SERVICE BULLETIN

| Classification: AT96-005 | Reference: NTB96-045 | Date: April 17, 1996 |

1995 MAXIMA AUTOMATIC TRANSMISSION (A/T) SHIFTER STICKING FROM SPILLED LIQUID

| APPLIED VEHICLE: | 1995 Maxima (A32) |

Figure 1

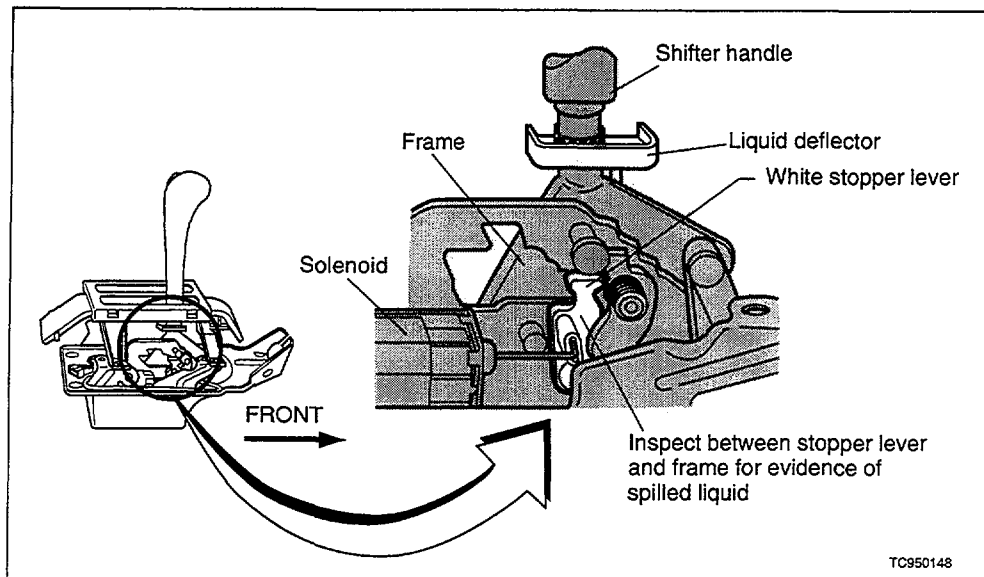
The A/T shifter may intermittently stick in the "Park" position. This incident may be caused by spilled liquids such as juice or soda coming in contact with the shift interlock mechanism. A countermeasure shifter control device, finisher, and cupholder are available to guide any liquids away from the shift interlock mechanism. These countermeasure parts have been installed during production on all Maximas beginning February 1, 1995.

1. Verify that all A/T shift components of the shift interlock system are functioning properly by following the diagnostic procedures on pages AT-118 to AT-121 in the 1995 Maxima Service Manual.
2. Verify the proper routing and installation of the key interlock cable by following the procedure on page AT-122 in the 1995 Maxima Service Manual.
3. Perform the shift lock solenoid component check as described on page AT-124 in the 1995 Maxima Service Manual. If the solenoid "clicks", but the white stopper lever doesn't move to the forward position, inspect the area for evidence of spilled liquid, as shown in Figure 1. If any evidence of spilled liquid is found, install the appropriate countermeasure A/T shift control device listed on page 2 of this bulletin.

4. Adjust the key interlock cable as shown on page AT-122 of the 1995 Maxima Service Manual.
5. Verify proper operation of the shift interlock mechanism.
6. Install a countermeasure finisher using the appropriate part listed in the table below.
7. Install the appropriate countermeasure cupholder/divider listed in the table below using double stick foam tape.
